SAN DIEGO REGIONAL
WATER QUALITY
CONTROL BOARD

September 5, 2012

Please see below the San Diego County Sanitation District's and Engineer of Record's comments to TENTATIVE ORDER NO. R9-2012-0054, WASTE DISCHARGE EQUIREMENTS FOR THE SAN DIEGO COUNTY SANITATION DISTRICT-HARMONY GROVE SERVICE AREA, HARMONY GROVE WATER RECLAMATION PLANT, SAN DIEGO COUNTY.

EXHIBIT A-1
WET WEATHER FLOW
PROCESS SCHEMATIC
HARMONY GROVE
WATER RECLAMATION PLANT

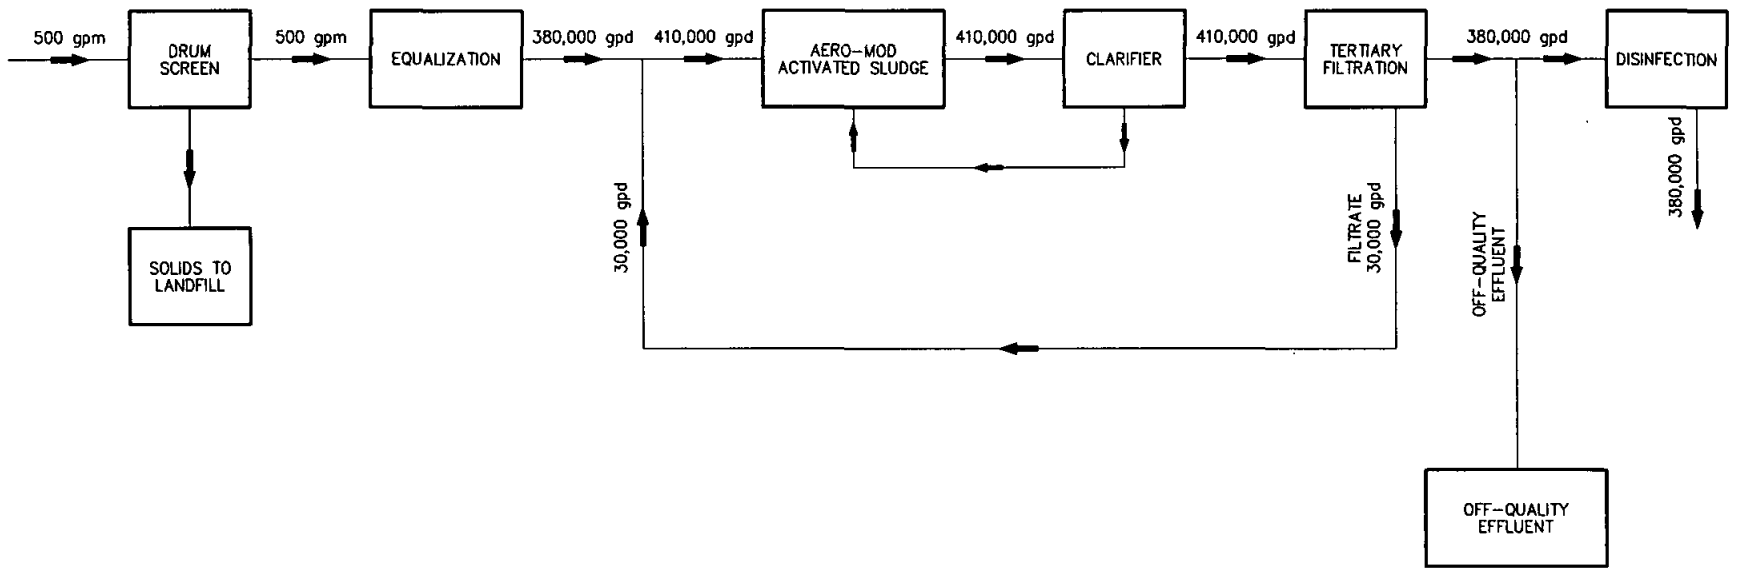
5. On page 7, C.5, also indicates that the average monthly effluent flow from the plant shall not exceed 180,000 gpd. The plant will have to discharge at a higher flow rate during wet weather or after peak flow conditions to empty the wet weather basin and prepare for the next wet weather season and avoid possible spills or discharge to surface waters. We suggest that the effluent flow rate limit is set at the average monthly effluent flow to 541,000 gpd or 376 gpm (please see the attached calculations from Dexter Wilson engineering).

IMPROVEMENT PLANS FOR:
PIPING PLAN
 HARMONY GROVE WATER RECLAMATION PLANT
 CALIFORNIA COORDINATE INDEX 338-1725

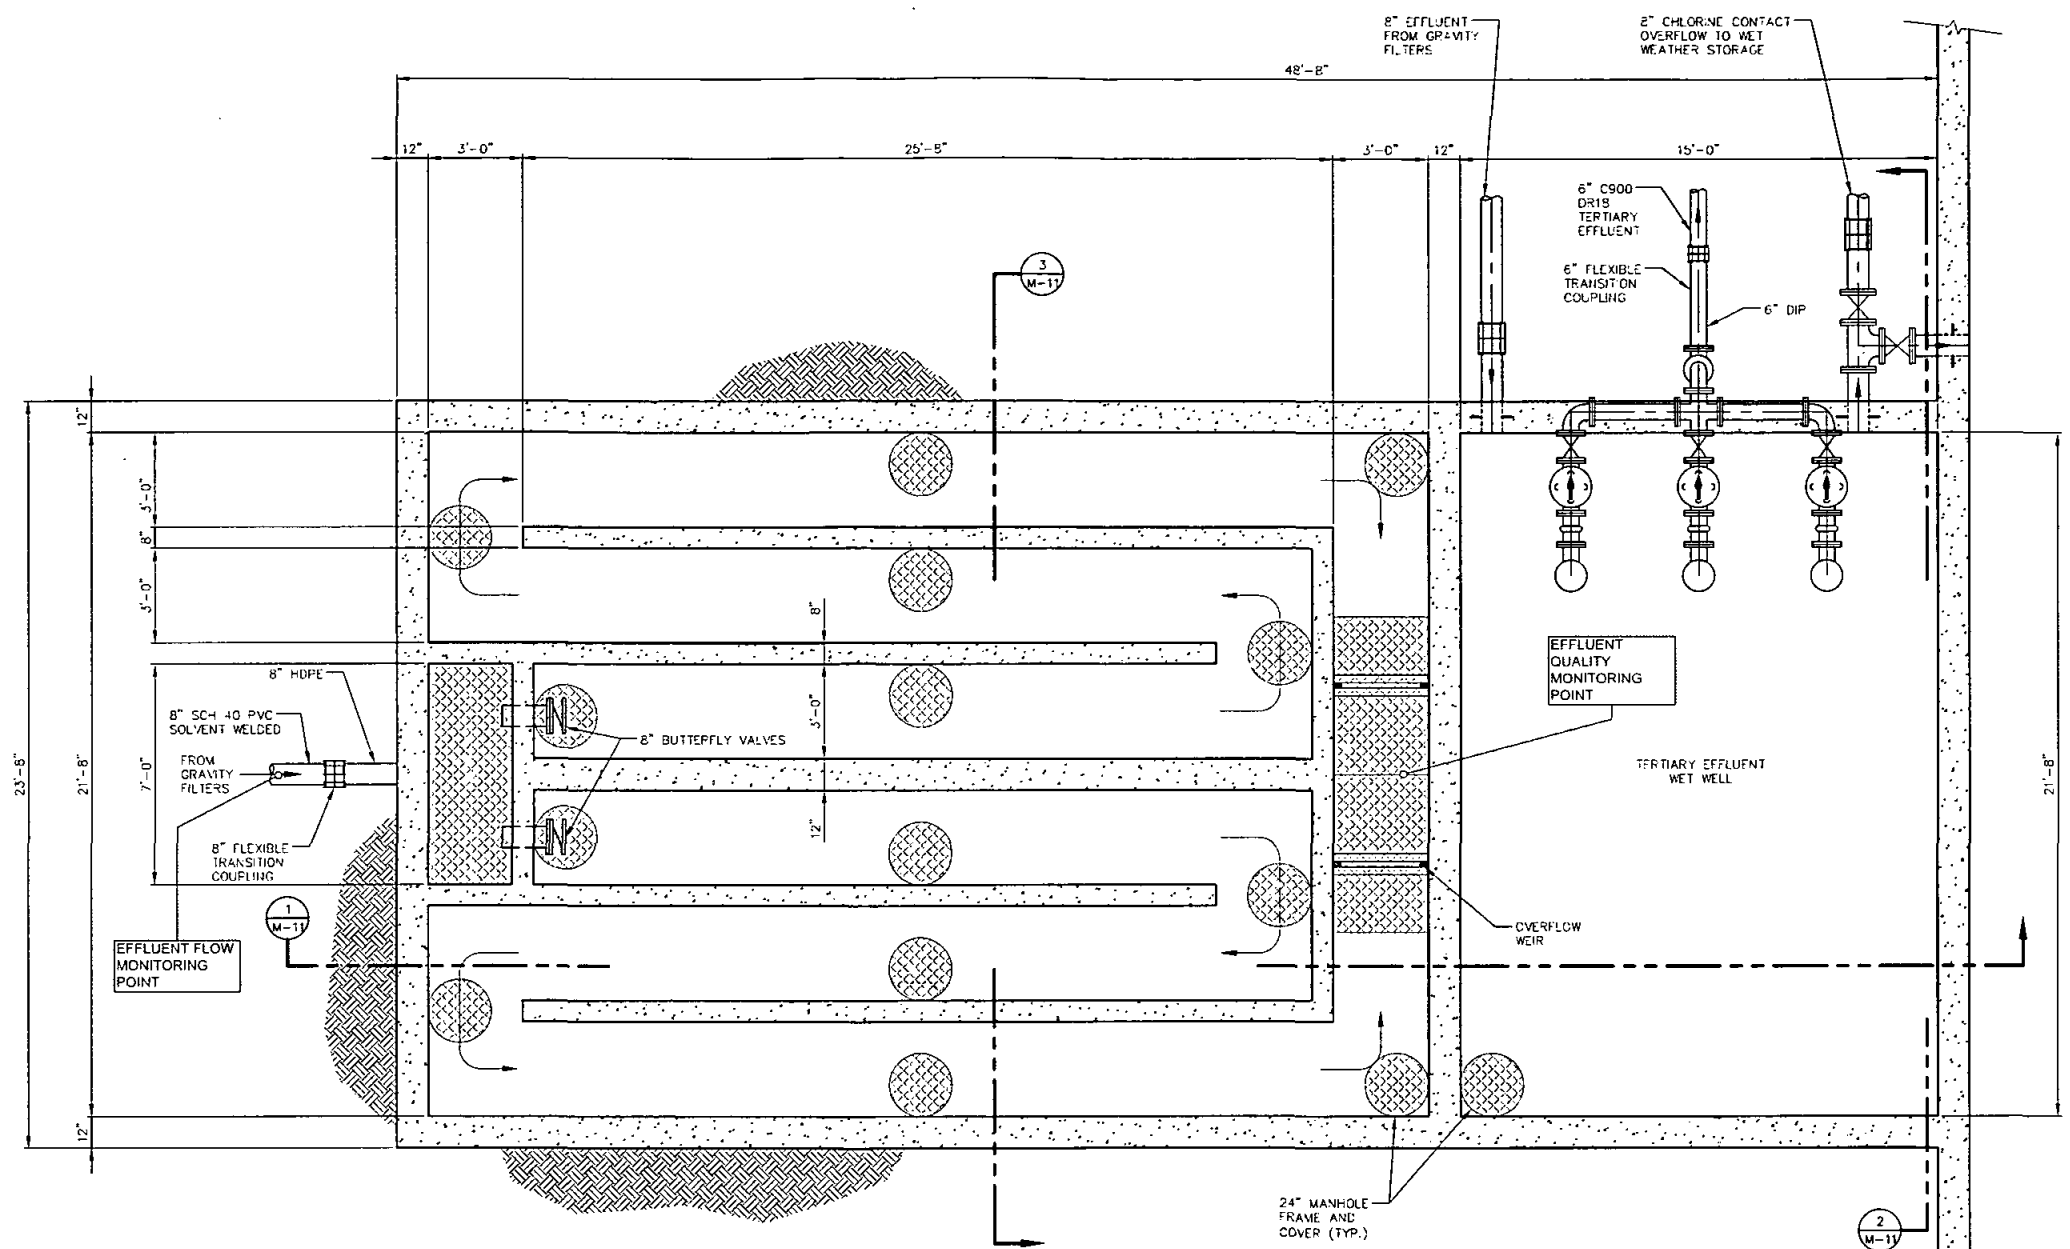
10. Page B-5, To avoid problems, it would be beneficial to identify the specific effluent monitoring locations (please see the attached marked-up drawing), of the tentative monitoring program, as follows:

The Discharger shall monitor the effluent quality at a point between the end of the chlorine contact basin and the entry to the tertiary effluent wet well in accordance Table B-1. Recycled water effluent flow shall be monitored after the gravity filters.
